ENGINEERING QUALITY INTO SAFETY SYSTEMS

Defense Nuclear Facilities Safety Board

Technical Report

March 2001

10 C.F.R. § 830.120 (c)(1)(i): PROGRAM

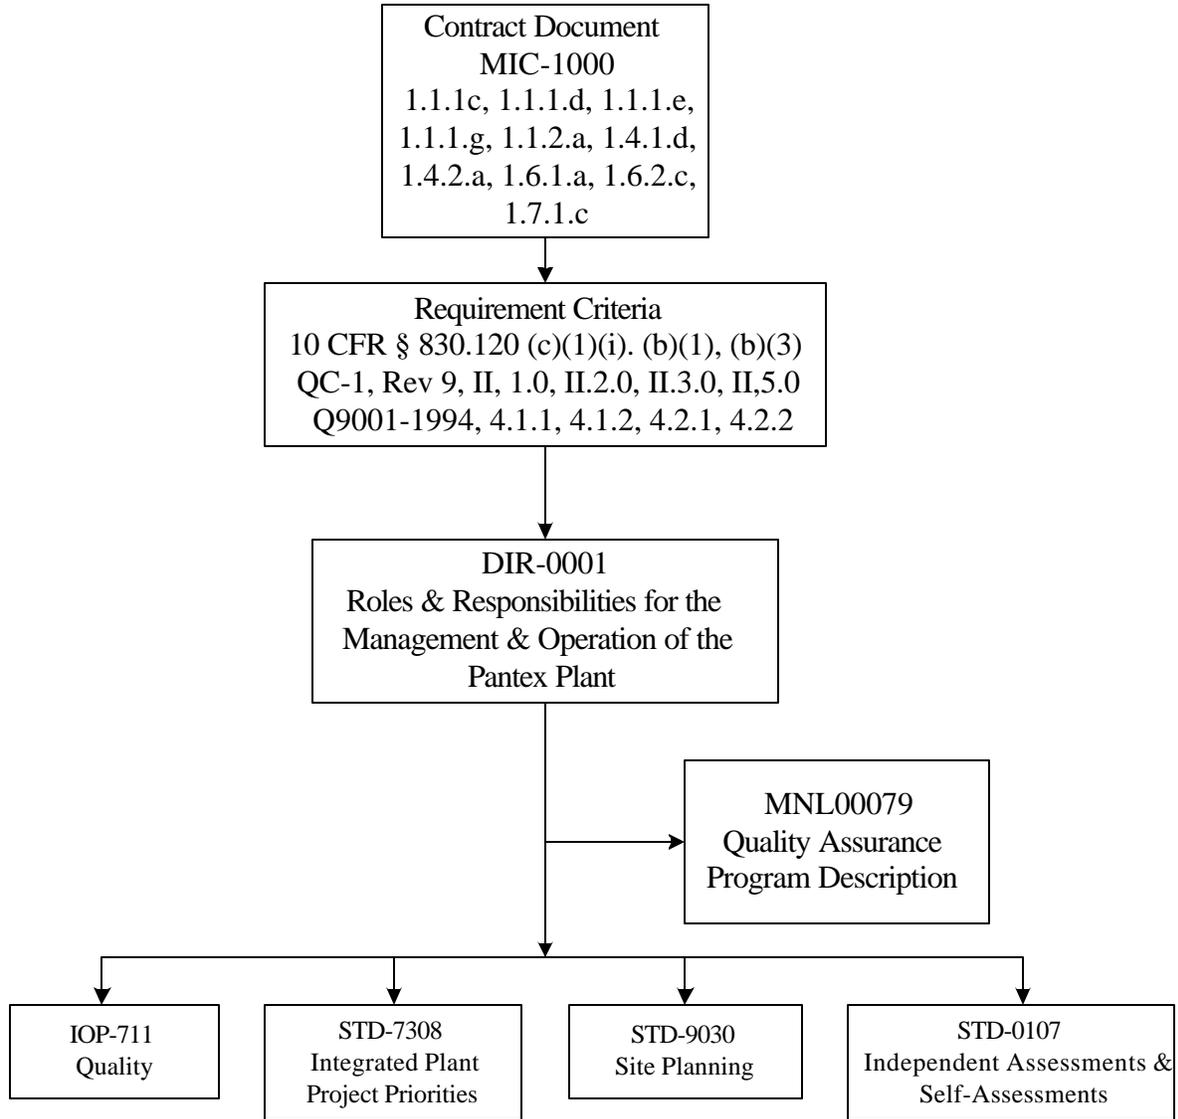
MIC S/RID criterion 1.7.1.b was omitted from the top level requirements.

10 C.F.R. § 830.120 (c)(2)(i): WORK PROCESSES

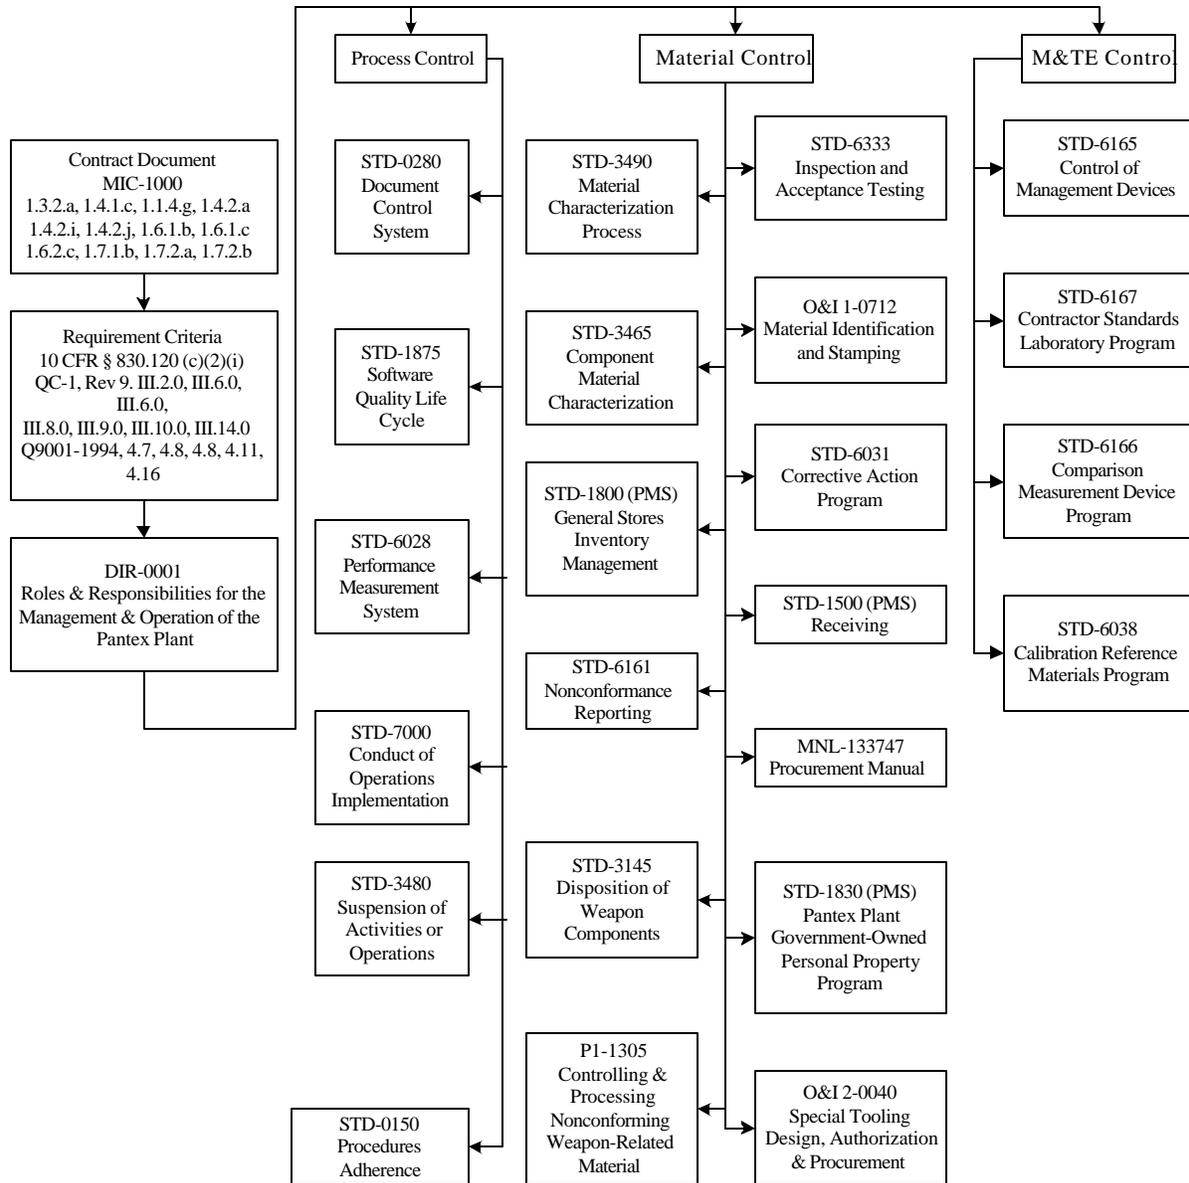
MIC S/RID criterion 1.3.1.k was omitted from the top level requirements

MIC S/RID criterion 1.7.1.b in the top level is incorrect – it should be 1.7.1.c.

MNL-FO-1106, *Maintenance Implementation Plan* was omitted from the list of site implementing documents

10 C.F.R. § 830.120 (c)(2)(ii): DESIGN

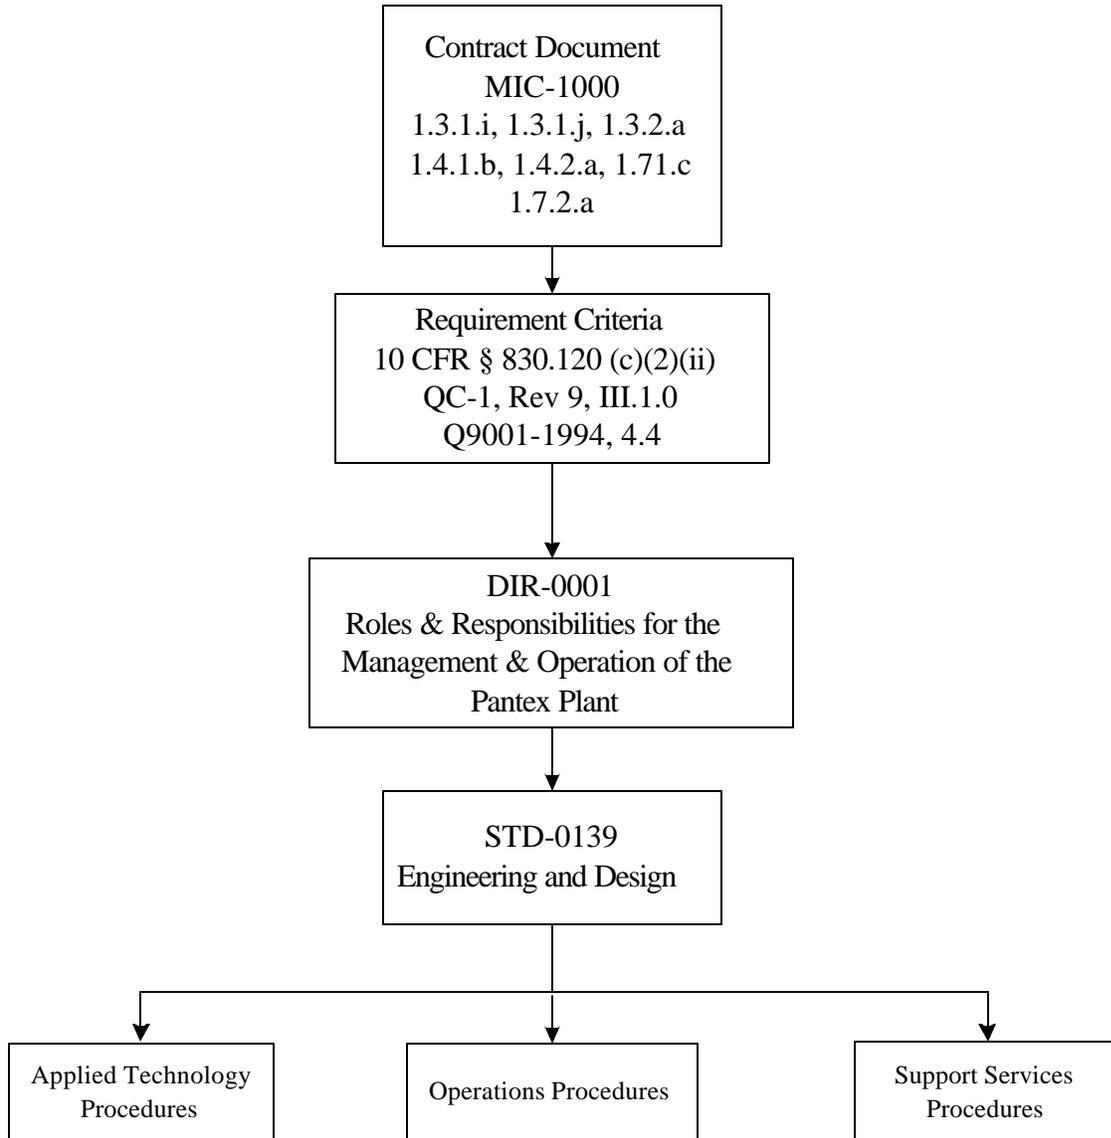
MIC S/RID criterion 1.71.c in the top level requirements is a typo – it should read 1.7.1.c

10 C.F.R. § 830.120 (c)(2)(iv): INSPECTION AND ACCEPTANCE TESTING

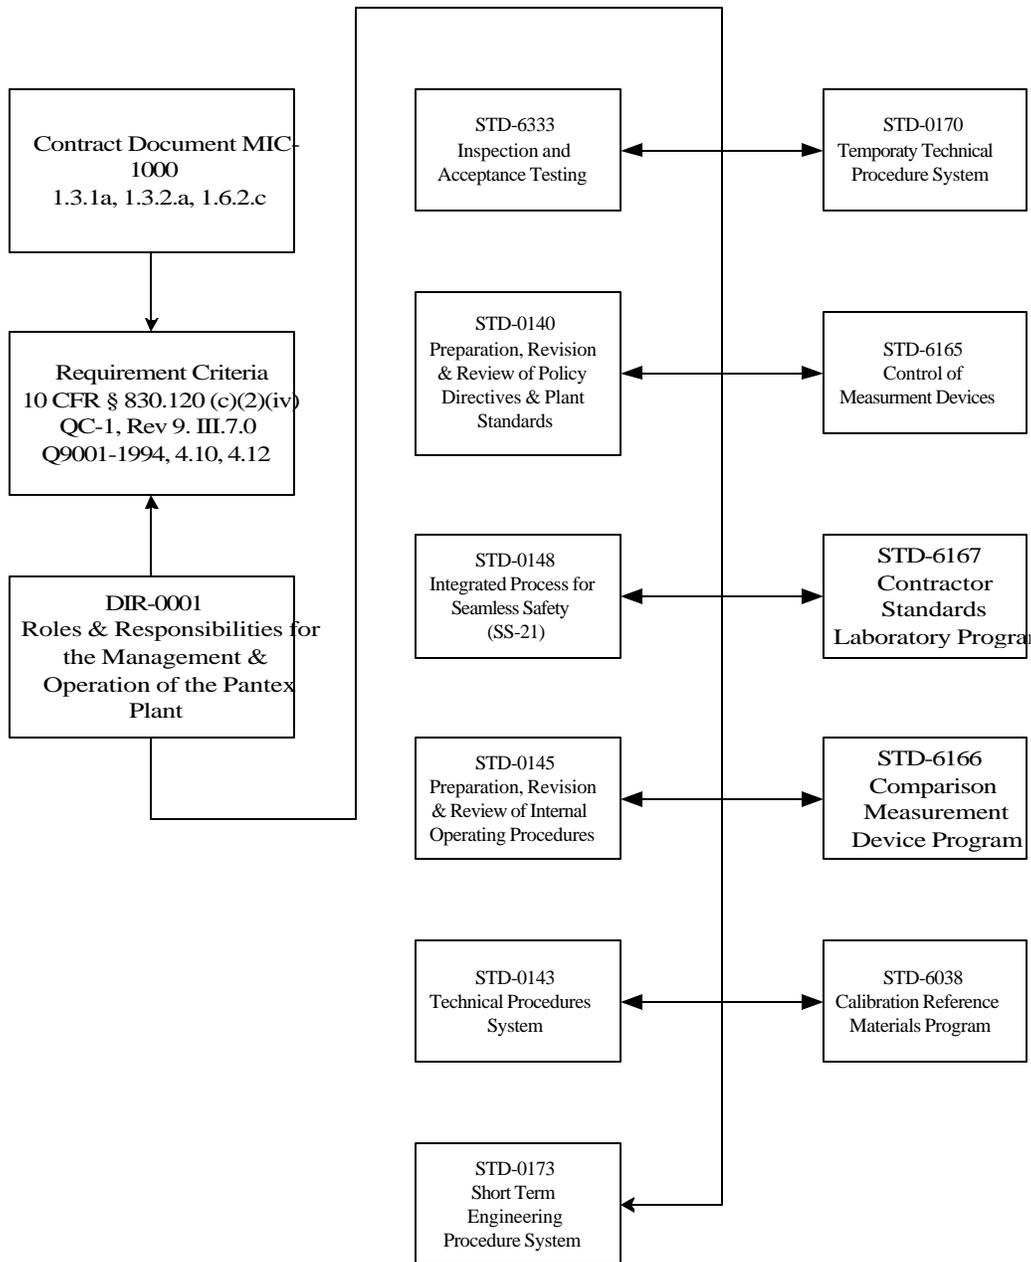
The following have been omitted from the list of site implementing documents:

IOP E-8602, *Validation of Nuclear Criticality Safety Computer Programs*

IOP E-4203, *Tooling & Inspection Requirements Form*
